# NORTHEAST UTILITIES

Millstone Nuclear Power Station, Unit No. 1  
Fire Protection Commitment - Blast Wall

NRC Commitment - SER Item 3.1.14

TURBINE BUILDING SEISMIC REVIEW

EBASCO SERVICES INCORPORATED		MILLSTONE UNIT NO. 1 TURBINE BUILDING	Fig. 1
DIV. Civil DR. MCH	APPROVED		
DATE CH			
SCALE

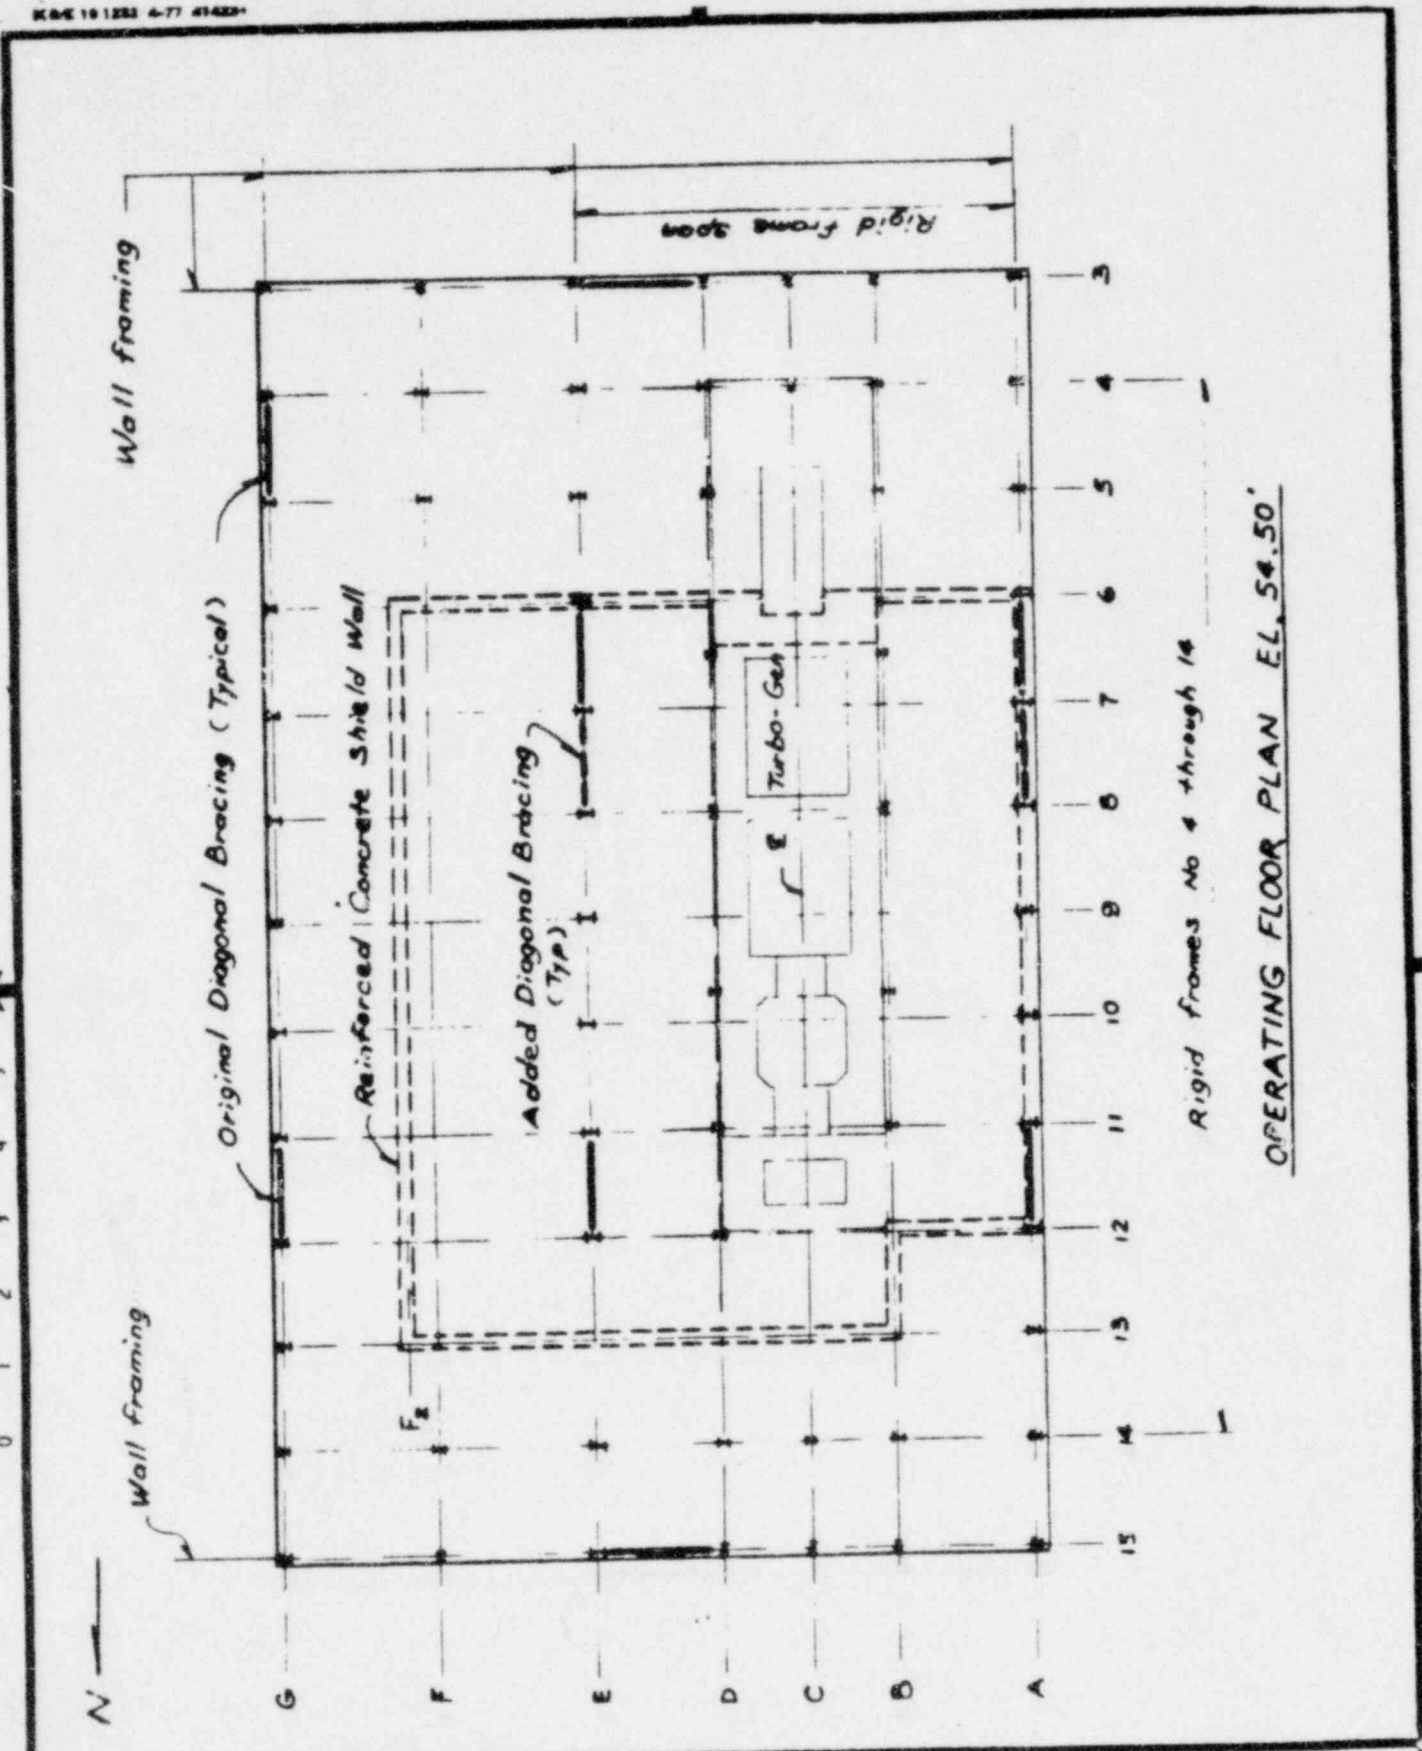
- A. Rigid Frames (Ref. Drawings: G-187985, 187989)  
As shown in Figure 1, the rigid frames were provided along Column lines 4 through 14 spanning between column lines A & E. Each frame, consisting of a steel girder and columns of the built-up type, provides support for the Turbine Building crane runway along column lines A and E at El. 86.42' and the roof deck at El. 104.75'. It was also designed to withstand any lateral loads in the East-West direction, wind or the crane thrust, that could be generated within the 25-ft. bay.

A typical frame (Column line 6) was checked for the postulated seismic conditions in the East-West direction assuming the entire crane dead load and associated seismic force to be resisted by the single frame under consideration. It was concluded that the original design was satisfactory under the postulated seismic conditions and no modification was required.

A 3-ft thick reinforced concrete wall was erected along column lines 6, 13, A and Fz as shown in Figure 1, enclosing the condensers, heaters, and condensate demineralizers. The concrete

The results of the review indicated that, under the postulated seismic conditions, the concrete shear stresses at all levels were well within the stipulated allowables.

Figure 2. DIAGONAL BRACING

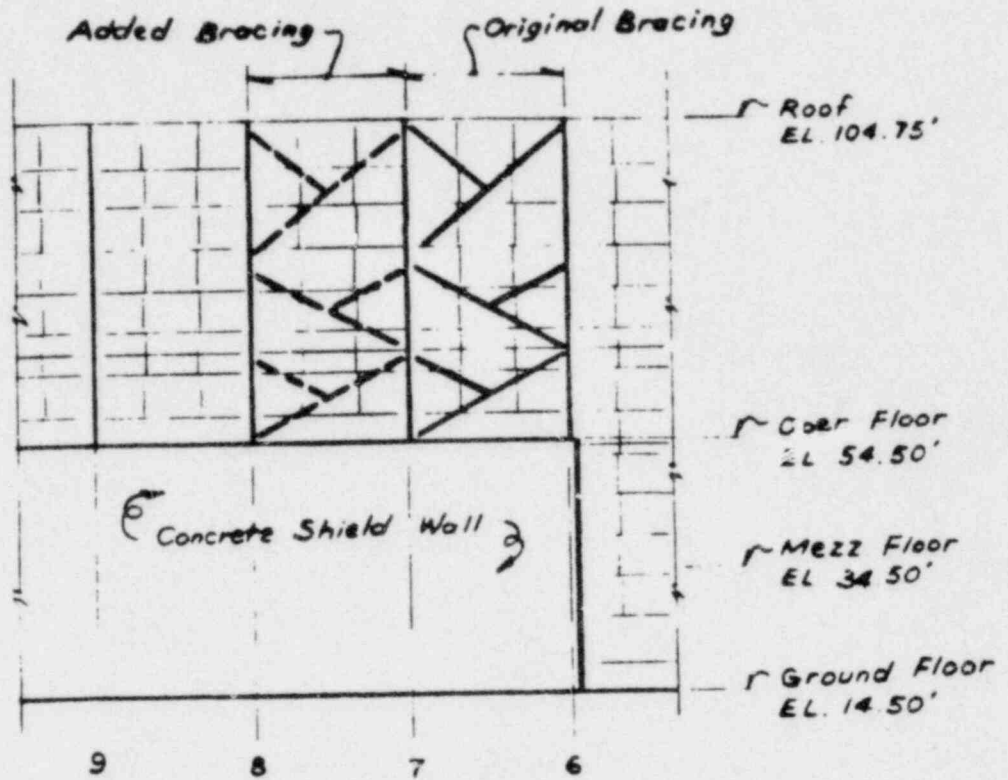
Each set of bracing was reviewed for strength and stability under the postulated seismic conditions and was found satisfactory except that located on Column lines A and B.

Instead of strengthening the originally designed bracing, a new set of bracing was installed between Column lines 7 and 8 on Column lines A and E as shown in Figures 1 and 2.

Figure 3

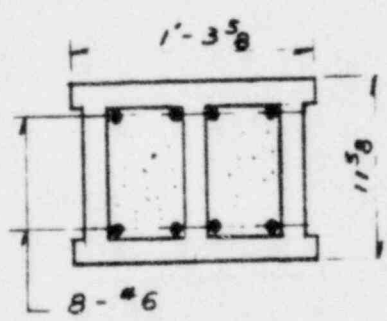
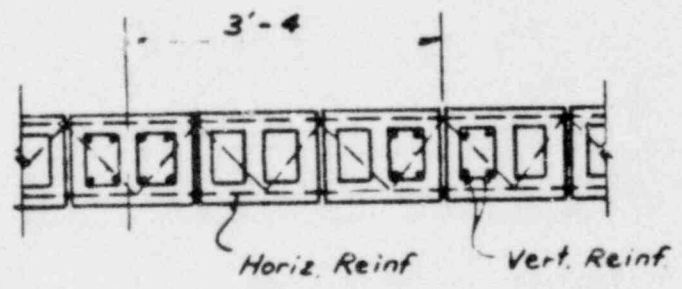
The Battery Room and Diesel Generator Room are enclosed by 12 in. concrete block walls designed to withstand a tornado wind of 300 mph (185 psf). As shown in Figure 3, the block walls were reinforced with 8-#6 verticals clustered every 3 ft 4 in. Prefabricated truss bars (Dur-o-wall) were provided at every second course for horizontal reinforcing. The tornado design was considered similar to the Design Earthquake with a factor of 2.4 and with allowables up to the yield stresses.

Seismic review calculations for the block have not been identified, however, the lateral loads that could be induced by the postulated seismic conditions would be less than the tornado load by observation.
